Access Compliance Report

Public Rights-of-Way

Intersection ID: 48421	Main Street: EVANTON_LOCH_RD	Cross Street: CULLEN_CT	Location: SE
ADA ID: 361ED2D72D31	Ramp Type: BlendTrans1	Initial Pass/Fail: Fail	Overall Compliance: No
		Severity Score: 10

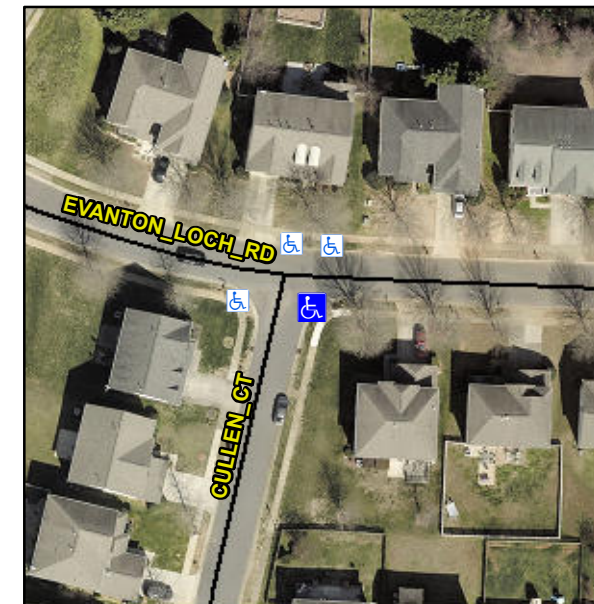
R304.5.1, R304.5.3

Compliance	Description	Data	Compliance	Description	Data
N/A	Ramp Length (in)	47.0	Yes	BlendTrans Slope (%)	3.9
No	Ramp Width (in)	43.5	No	BlendTrans XSlope (%)	2.5
N/A	Flare Type LT	N/A	N/A	Flare Type RT	N/A
N/A	Flare Slope LT (%)	N/A	N/A	Flare Slope RT (%)	N/A
N/A	Flare Traversable LT?	N/A	N/A	Flare Traversable RT?	N/A
N/A	Landing Length (in)	N/A	N/A	DWS Provided?	N/A
N/A	Landing Width (in)	N/A	N/A	DWS Contrast?	N/A
N/A	Landing Slope (%)	N/A	N/A	DWS Length (in)	N/A
N/A	Landing X Slope (%)	N/A	N/A	DWS Full Width?	N/A
N/A	Landing Curb? (Y/N)	N/A	N/A	DWS Offset (in)	N/A
N/A	Shared Landing?	N/A			
N/A	Gutter Ponding?	N/A	N/A	Gutter Slope (%)	N/A
N/A	Gutter Lip Ht (in)	1.0	N/A	Gutter X Slope (%)	N/A
N/A	Painted X Walk1?	No	N/A	Painted X Walk2?	No
	X Walk 1 Direction	To N		X Walk 2 Direction	To W
	X Walk 1 Width (in)	N/A		X Walk 2 Width (in)	N/A
	X Walk 1 Slope (%)	2.5		X Walk 2 Slope (%)	0.5
	X Walk 1 X Slope (%)	0.4		X Walk 2 X Slope (%)	2.1

Remove & Replace Curb Ramp With Two New Directional Ramps or Equivalent.
